R12TU

**Recall R12TU
Braun Lift Outer Rollstop Latch Recall
Recall Completion Reply Sheet**

Service Bulletin 37679

Outer Barrier Latch, Bracket, and Clevis Pin Retrofit 37679

Figure 1

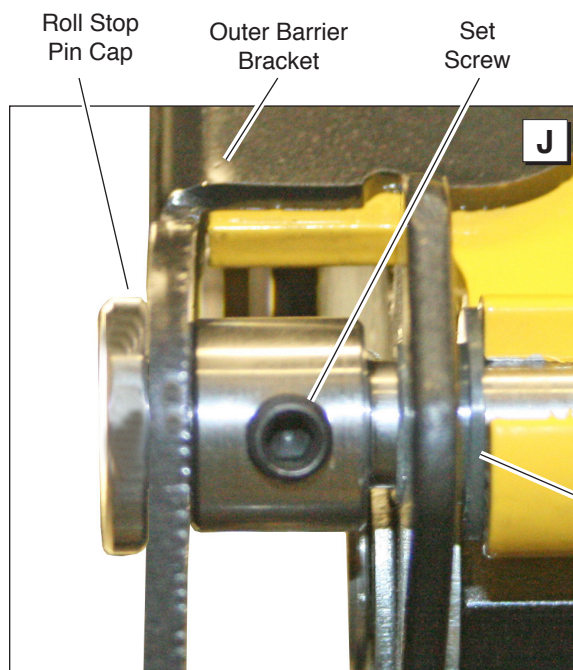
8. Install replacement outer barrier bracket/latch assembly using hex socket and washer removed in step 4. Apply Loctite® Threadlocker Blue 242™ or equivalent on threads. Refer to Photo A and Figure 1.

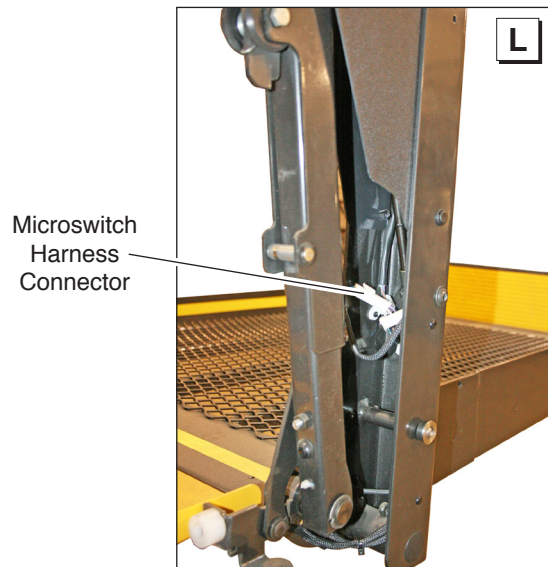
14. Install replacement outer barrier latch/bracket assembly using hex socket and washer removed in step 4. See Figure 2.
